GENERAL NOTICES AND REPORTS ON WELLS
Do not use this form for proposals to drill or to re-enter an abandoned well. Use form 3160-3 (APD) for such proposals.

** BLM REVISED ** BLM REVISED ** BLM REVISED ** BLM REVISED ** BLM REVISED **

South Paw 30 Federal #1

30-025-36547

W B D (P + A)

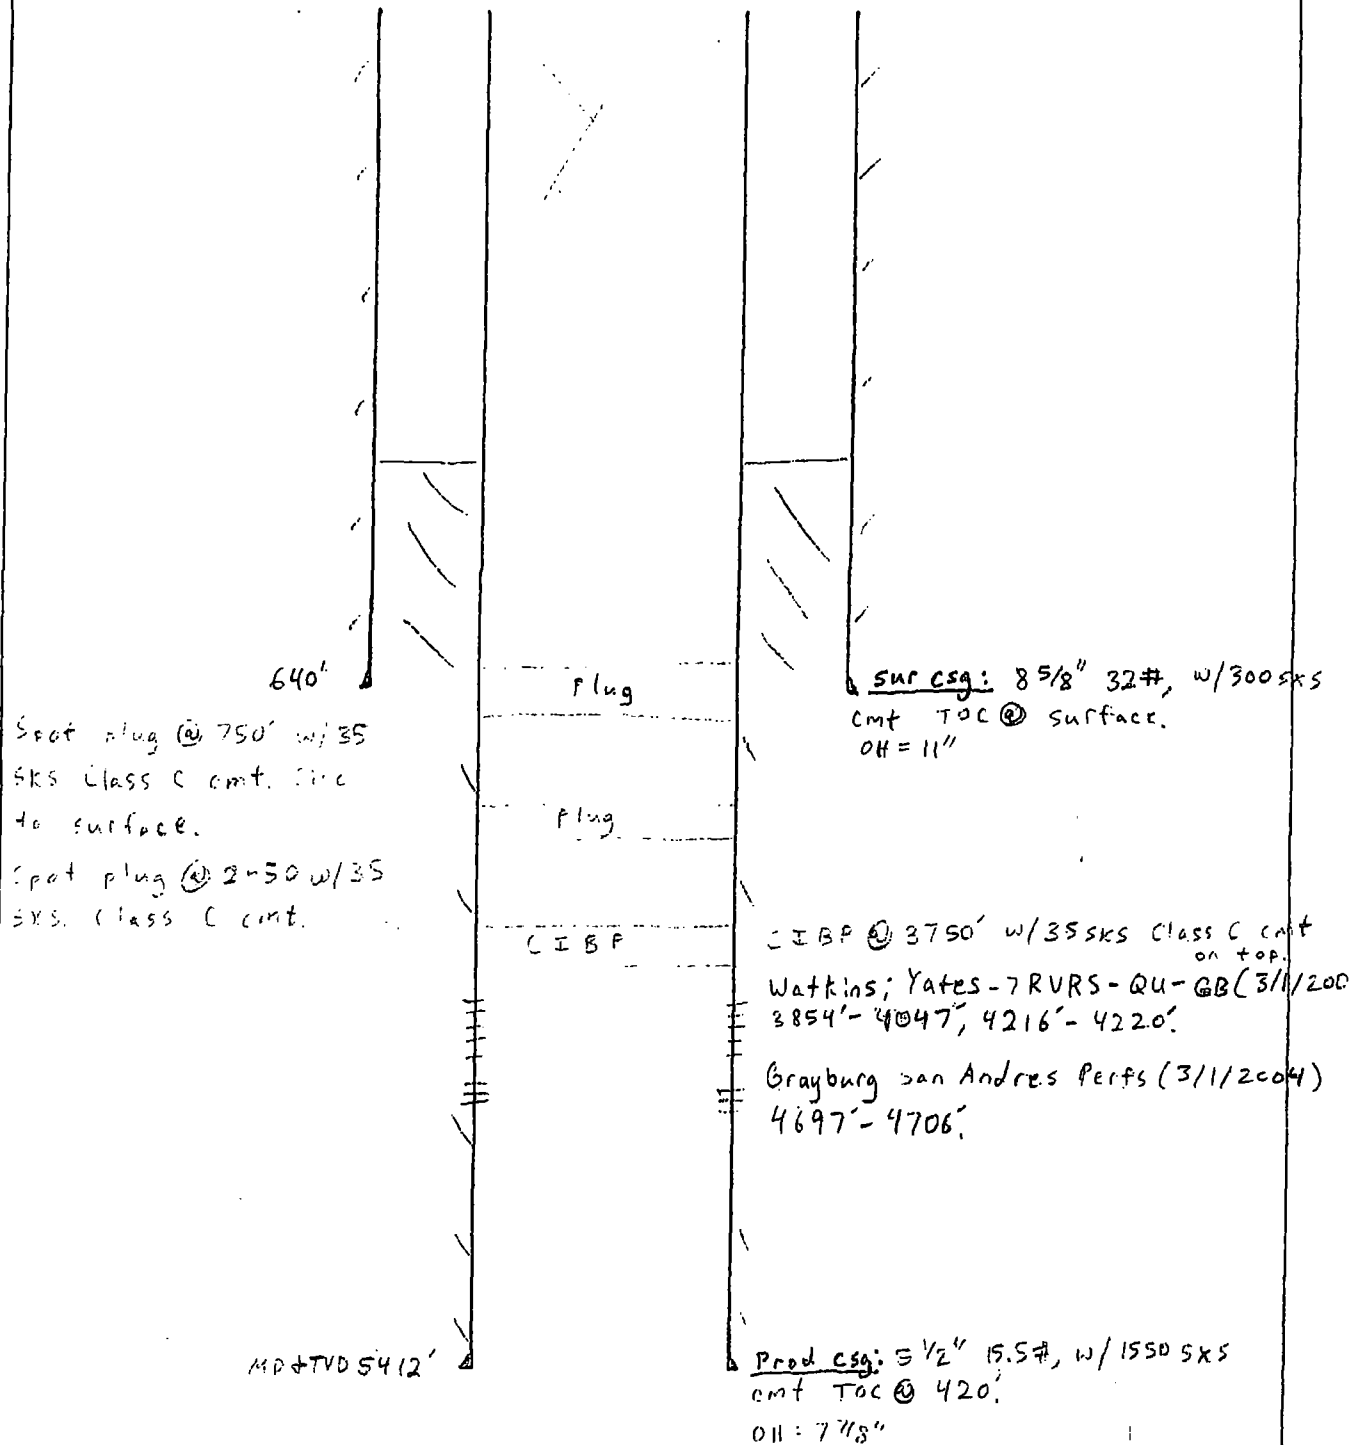
2320 Add Plug from 1358-1258. WOC 25 sxs min. Tag

8. Perf to 60' 502 cmt Surf.

Below ground level dry hole marker required
